DESIGN FEATURES

5.6 FUEL STORAGE

FIGURE 5.6-1
ASSEMBLY BURNUP VERSUS INITIAL ENRICHMENT.

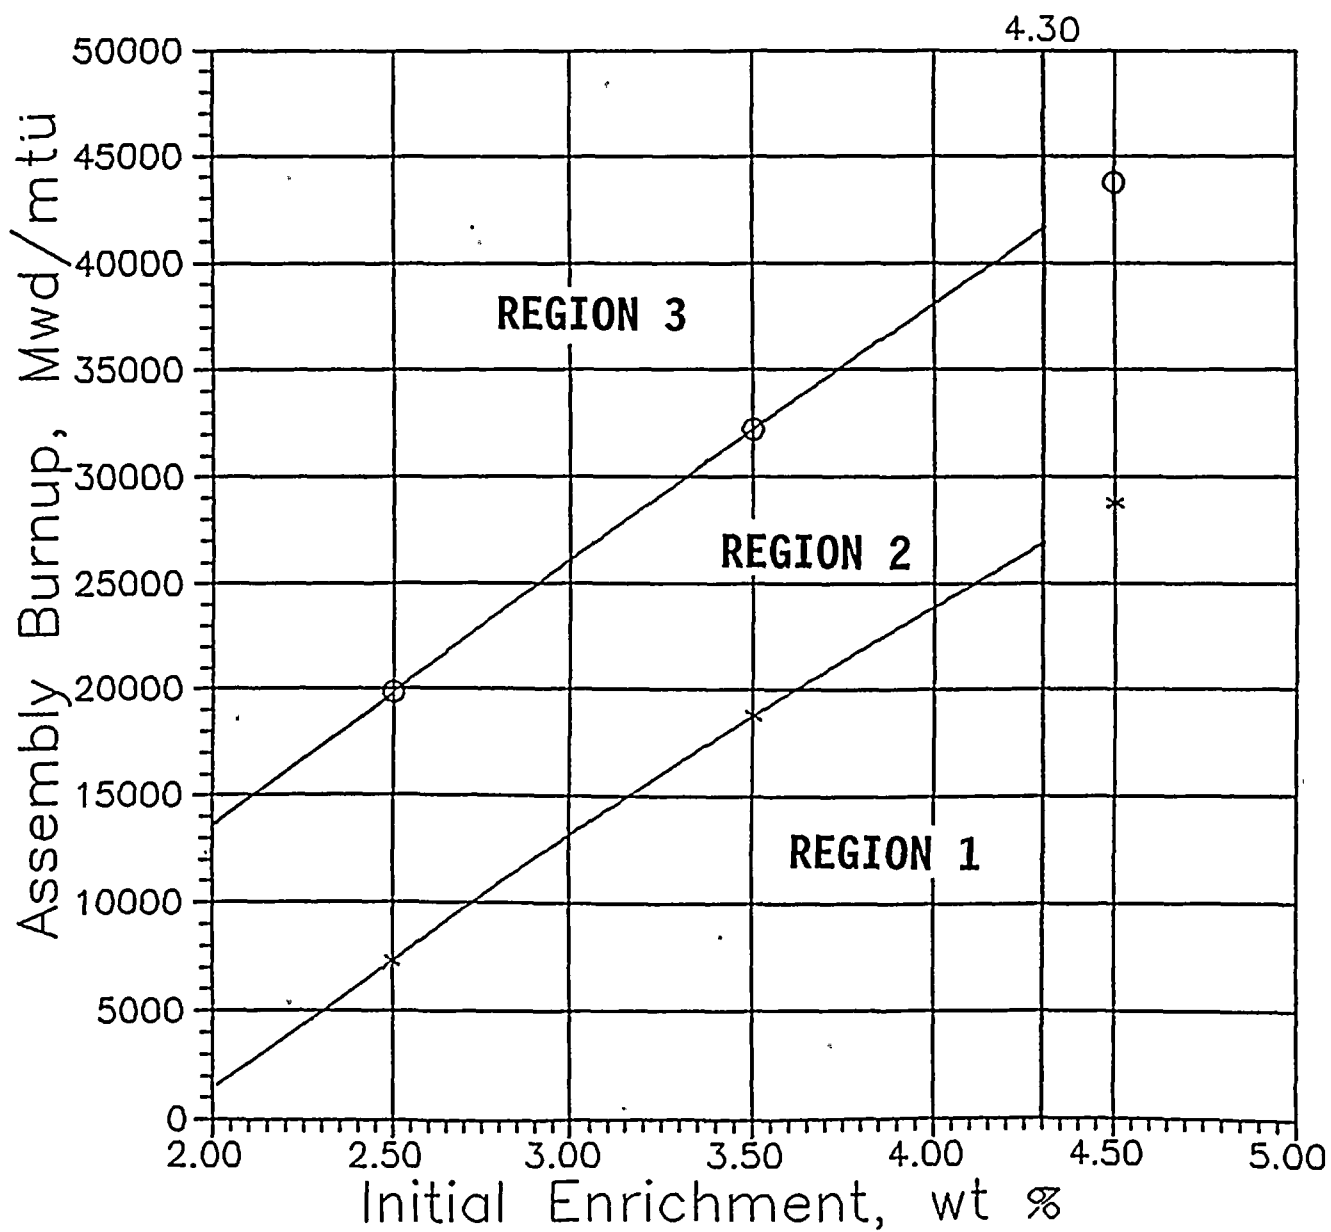
- Insert B* →
- ~~k_{eff} equivalent to less than or equal to 0.95 when flooded with unborated water, which includes a conservative allowance of 2.6% delta k/k for uncertainties as described in Section 9.1 of the FSAR.~~
 - A nominal 9.5 ^{inches} center-to-center distance between fuel assemblies placed in the storage racks in a high density configuration *adjacent storage cell locations.*

⇒ *Insert C*
DRAINAGE

FIGURE 5.6-1
ASSEMBLY BURNUP VERSUS INITIAL ENRICHMENT.

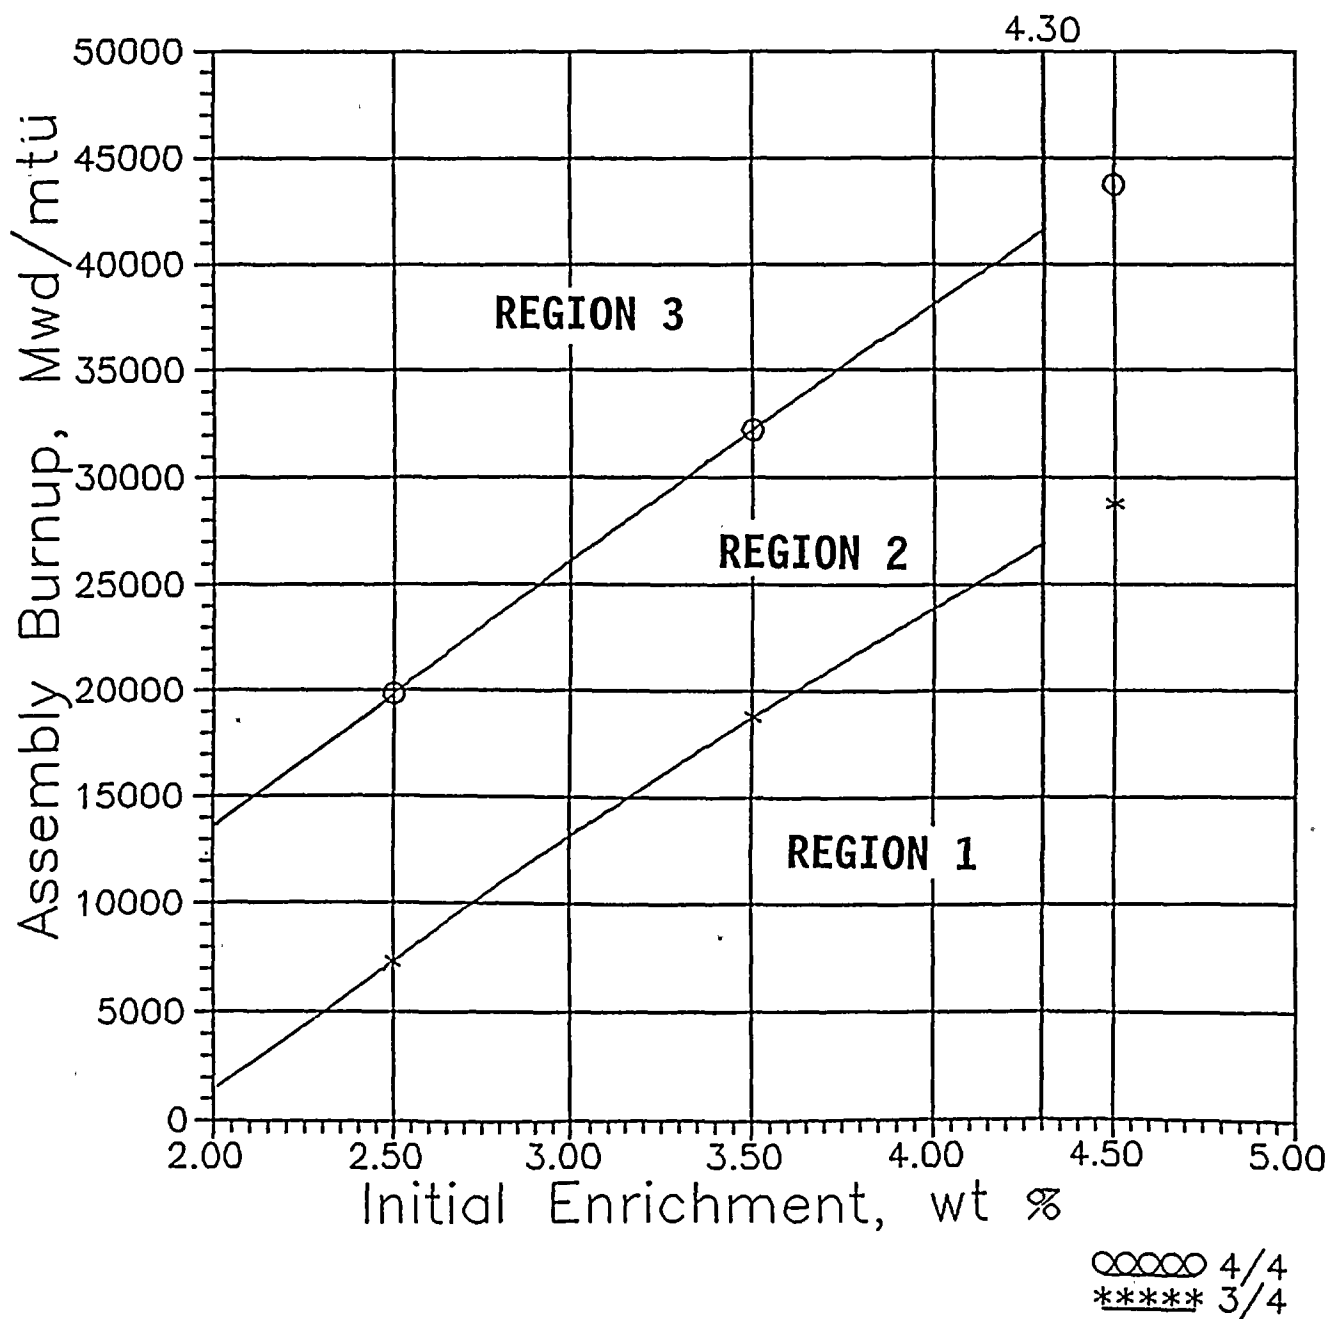
- Insert B*
- a. ~~A k_{eff} equivalent to less than or equal to 0.95 when flooded with unborated water, which includes a conservative allowance of 2.8% $\Delta k/k$ for uncertainties as described in Section 9.1 of the FSAR.~~
 - b. A nominal 9.5 ^{inches} center-to-center distance between fuel assemblies placed in the storage racks in a high density configuration *adjacent storage cell locations.*

Insert C
DRAINAGE
